Product Change Notification					PCN FSW and FMxB case MB redesign		
owner	creation date	release date	released by	change order no	rev	page	D10-058-234
doriaan	04.06.2021	23.06.2021	blumhe	2022133	A	1 of 3

Old product appearance (example)	New product appearance (example)

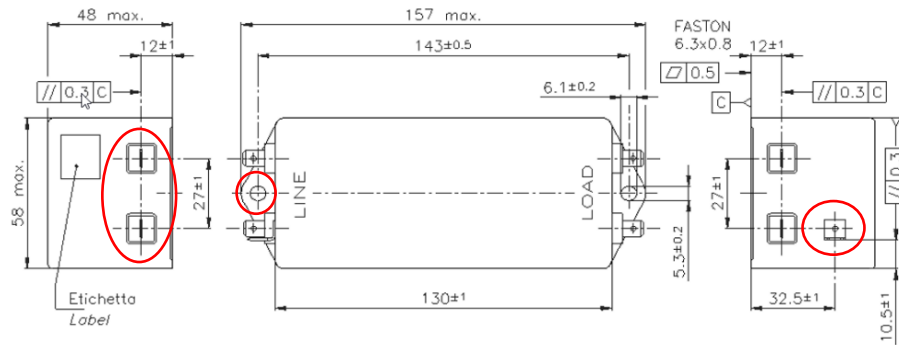
- Change of product appearance due to new nickel plated case instead of aluminium case and different shape of plastic part for quick connect terminals see photo below
- Different shape of plastic part for external quick connector terminals
- Position of earth terminal

Case MB with quick connect terminals

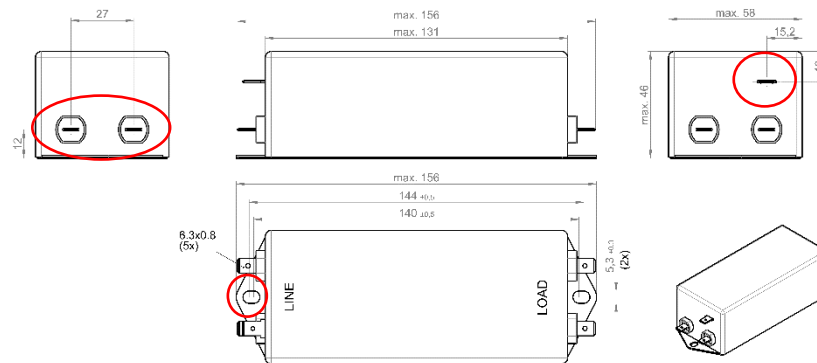
- Nickel plated case instead of aluminium case
- Different shape of external quick connect terminals
- Changed ground terminal position
